Product Change Notification

Change Notification #: 110013 - 00
Change Title: Intel® Server Accessory AXXHERAIL2, PCN 110013-00, Product Design, Change eight rivets to screws
Date of Publication: May 17, 2010

Pre Change Rail:

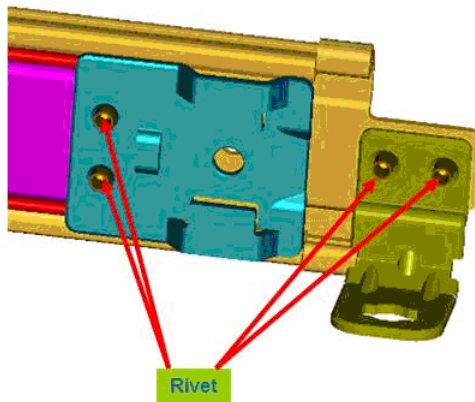
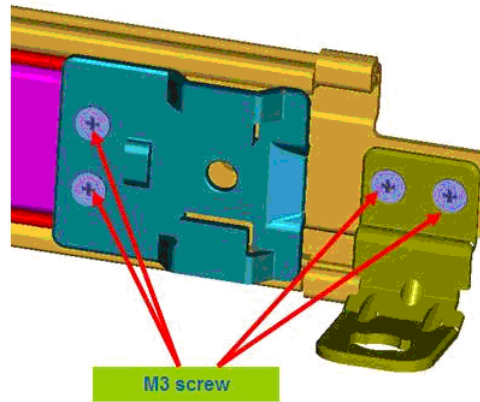
The attach method for 2 brackets at the rear of the rails is being changed from rivets to screws. This will allow the brackets to be removed if required.

Current design-4 rivets per rail arm

After change-4 screws per rail arm
